Questions and Answers

Here you can find answers to questions the DEA receives continually. General updates on the dialogue between the DEA and relevant stakeholders can be found under Large-scale Offshore Wind Tenders.

Everything below the category "General" is regarding Kriegers Flak.

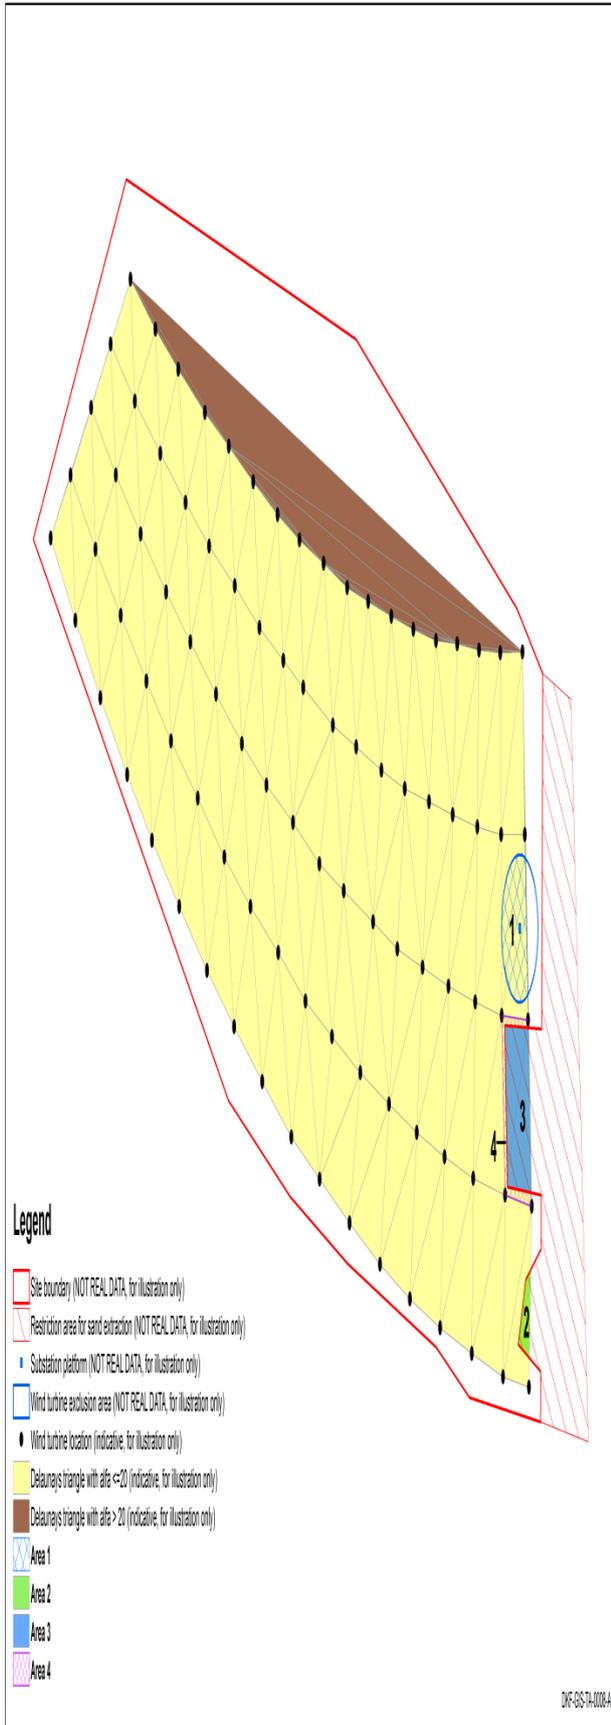
Area 1 – area is within the Delaunays triangle with $\alpha \leq 20$ and within 1 km buffer from substation platform.

Area 2 and 3 – area is within the Delaunays triangle with $\alpha \leq 20$ but outside of site boundary (within sand extraction restriction zone)

Area 4 - area is within the Delaunays triangle with $\alpha \leq 20$ but it forms a slither resulting from majority of the Delaunay triangle with $\alpha \leq 20$ being outside of site boundary.

Consequently it means that in the illustration for this question, area 1 will be excluded from the calculation of wind farm area, while areas 2, 3 and 4 will not.

Q (24.05.2016) Wind farm area and cables

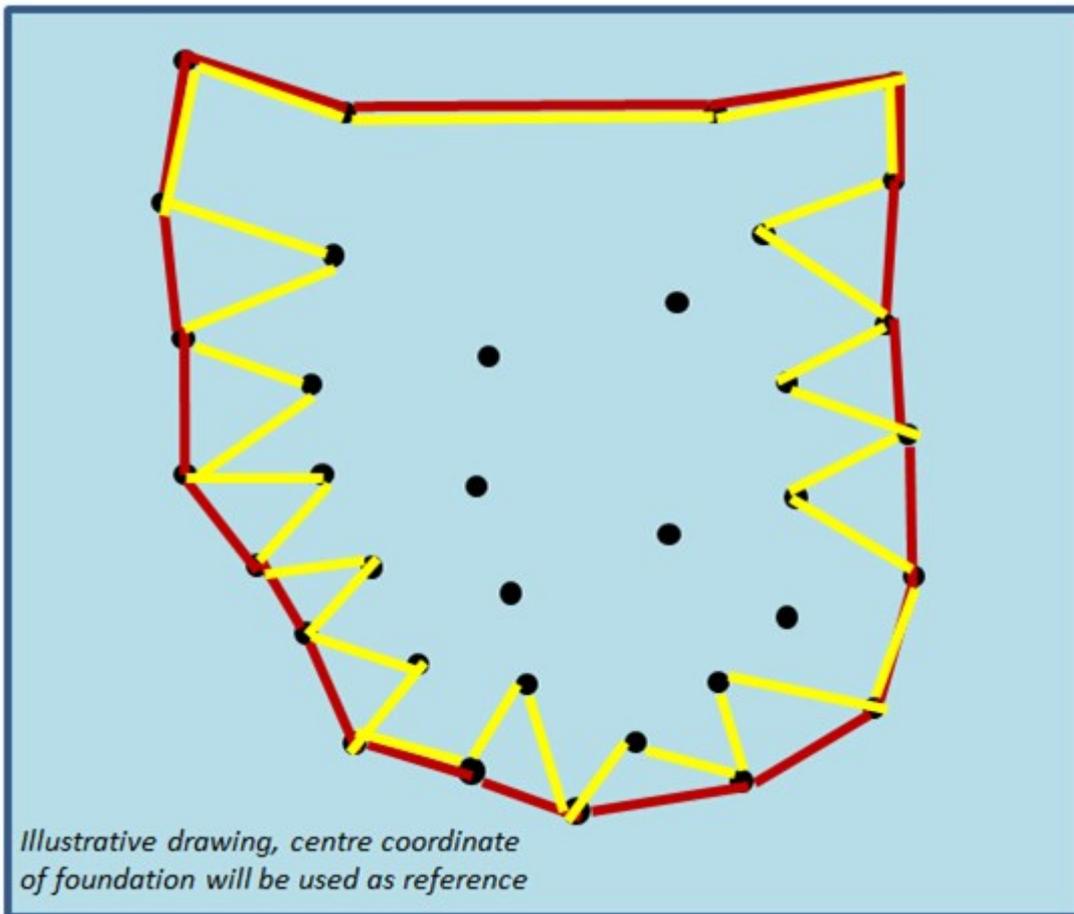
Can the DEA confirm that:

1) A 0.22km²/MW ratio will be applied to derive the exact WTG area for area A and B (following also the ~200 MW and ~400 MW restrictions accordingly), allowing for some re-sizing of area due to over/under planting, and potential moving of up to ten turbines from the eastern to the western area.

Figure 11-1 Depth below seabed (DBS) in m of Hazard Blanking Unit

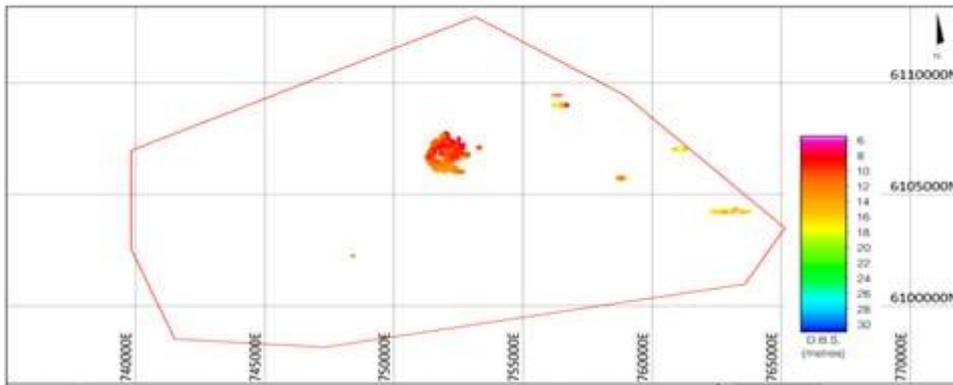
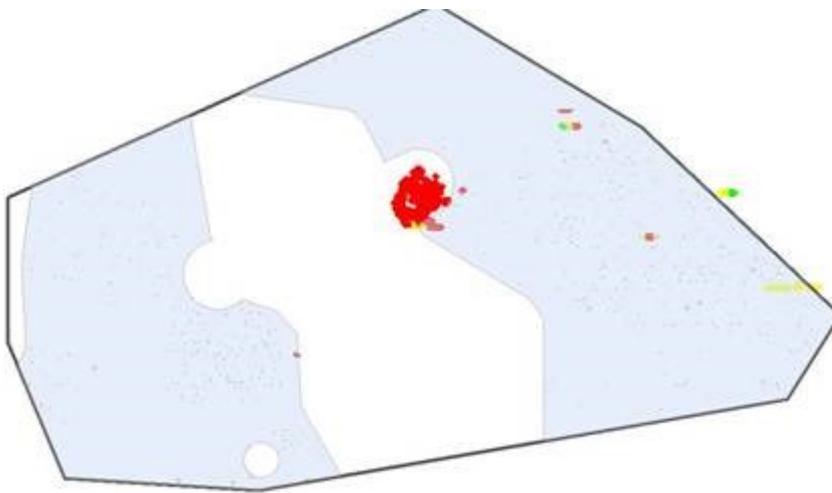
In the geophysical reports for the Kriegers Flak OWF pre-investigation area, eg. "Kriegers Flak OWF, Geophysical survey results", by Ramboll, August 2013, sub-areas at relatively shallow depths was mapped due to distinct 'blanking' and/or 'phase reversal' in the seismic records (see the figure below which is a copy of Figure 11-1 in the above report).

Figure 11-1 shows depth below seabed (DBS) in m of the Hazard blanking unit (potentially hazardous area).

The 'blanking/phase reversal' zones were tentatively interpreted to be caused by accumulation of gas produced in and migrating from possible organic rich units below the top of the zones. One larger gas blanking area was mapped in the mid north-eastern part of the KF OWF pre-investigation area. The top of the blanking in that area is located c. 9-13m below seabed.
